Technical Bulletin

DP02	TB0028-2008	Elan Motorsports Technologies	
From:	Chip Lewis		
Subject:	<i>2008 Adjustable Alternator Mount</i>	Date:	May 30 th , 2008

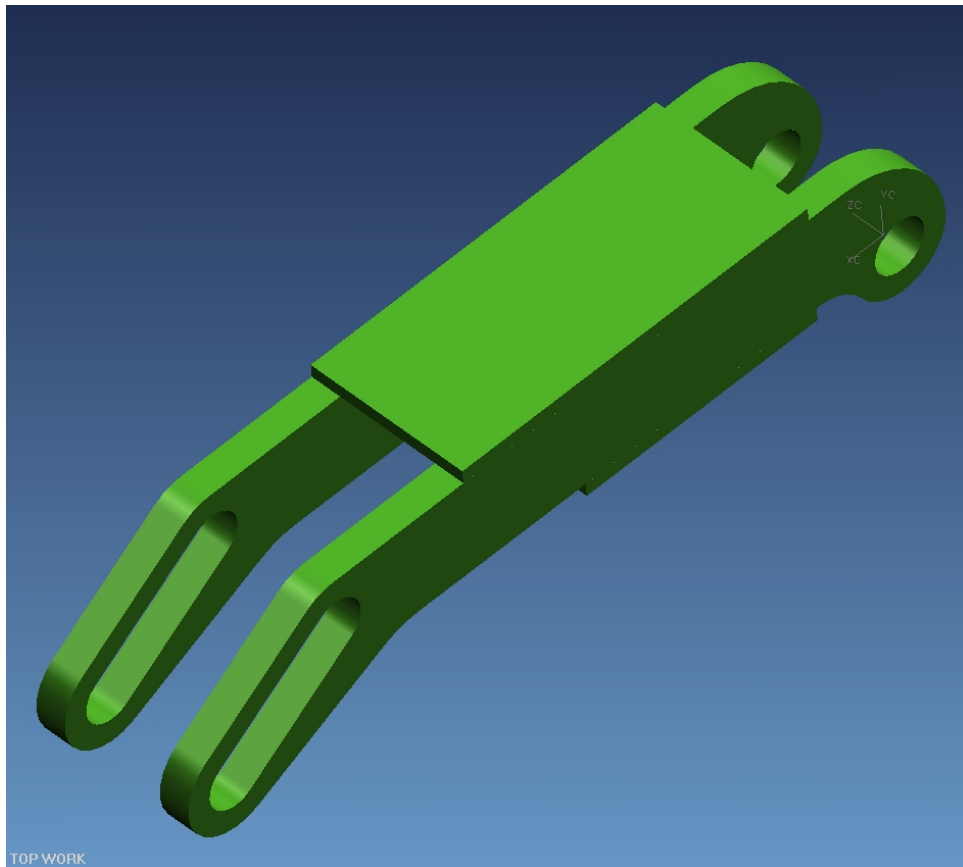
Available to order is a new Adjustable Alternator Mount, DP02-60-044, issue 4. The new arm is an improved version to prevent the breakage that occurred in a few of the previous units. The new version has thicker section steel.
